ADDENDUM TO RFP DOCUMENTS

<p>SOLANO COMMUNITY COLLEGE</p>	ADDENDUM #02
	SCCD RFP: #17-008
	Project: Solano Community College District Fairfield Campus Entry Sidewalk Improvements
	Date: July 12, 2017

C1.0

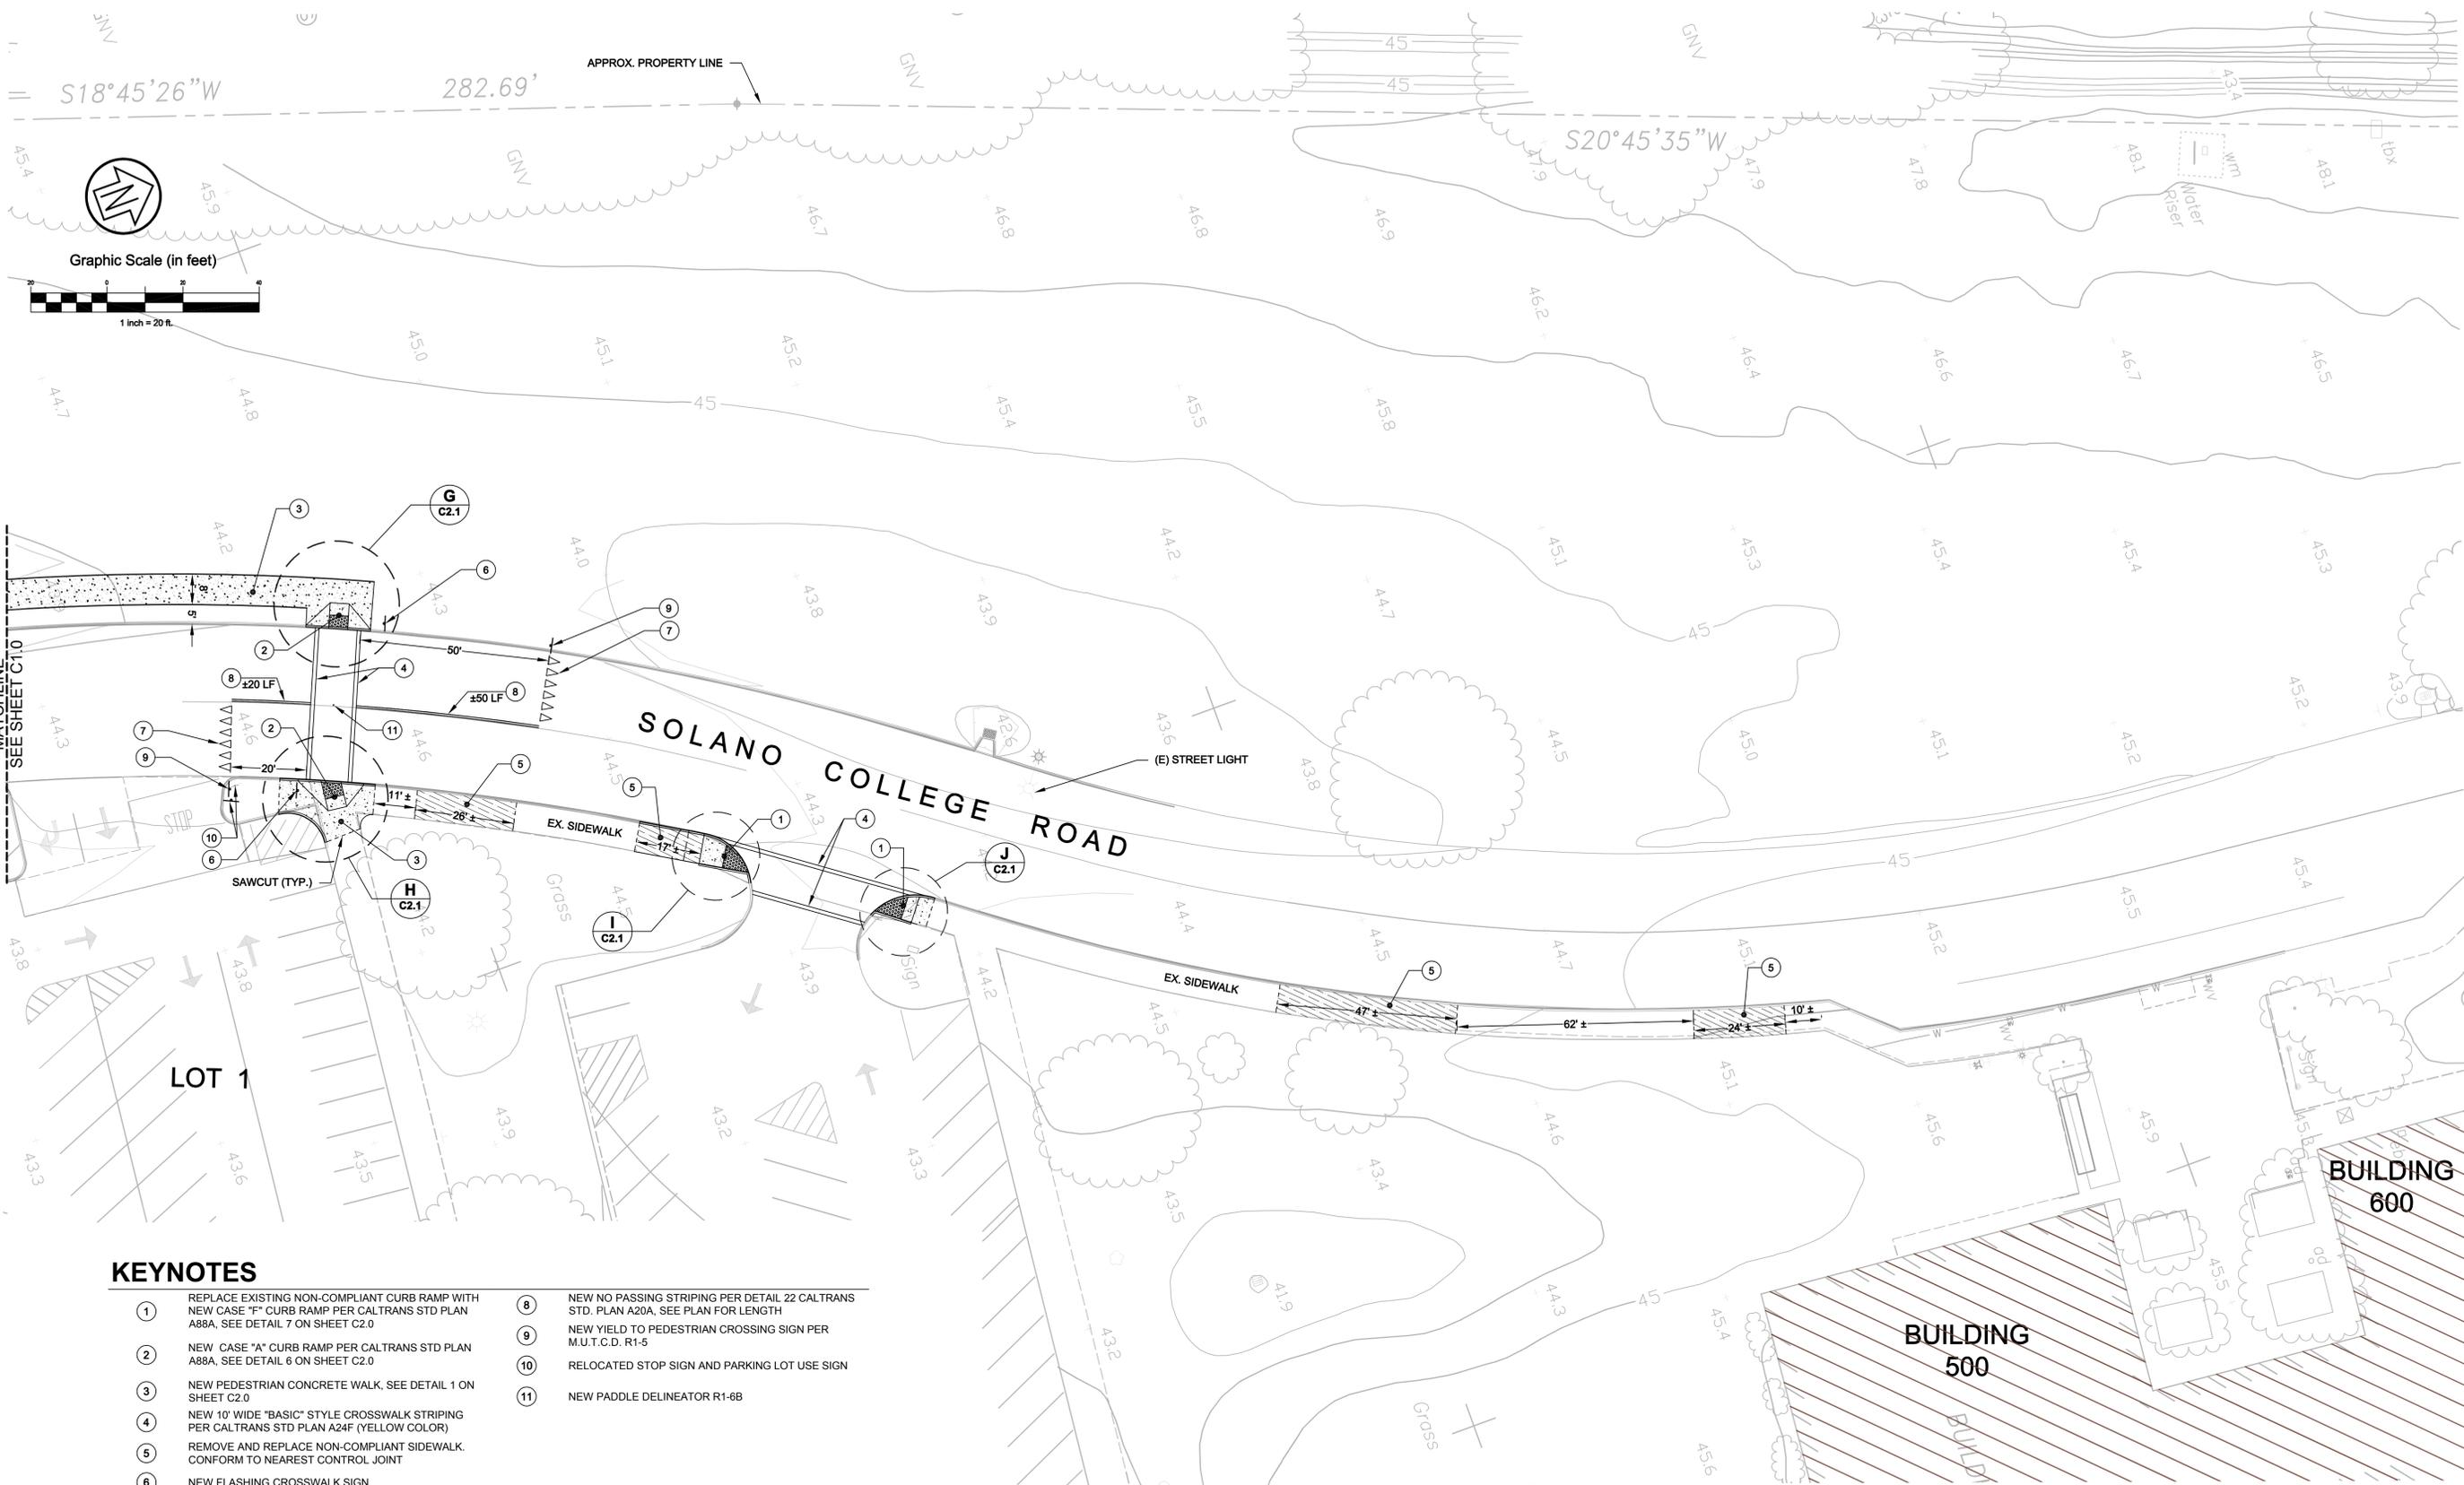
7. C1.0 note 17 calls out removal of existing hedge. Contractor shall also remove roots to enable smooth, conforming grades and successful grass planting.

- c. Sheet C1.0 Question: conduit run (note 20): should a pull box be added to this 233 ft. (approximate) segment? Answer: an intermediate box may be added for contractor's convenience however code does not require.

COMBINED STREET SIGN
PUSH BUTTON ASSEMBLY POST
DETAIL C

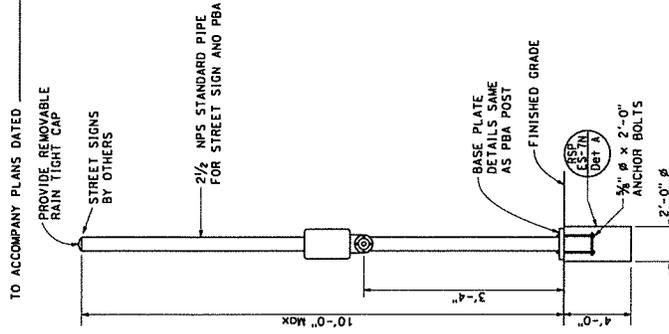
- d. Pole and foundation: Poles and foundations shall conform to Caltrans RSP (2015) ES-7A, Detail C (attached)
11. Contractor's attention is directed to General Notes, section 8 in the Special Conditions Document 00 73 13.
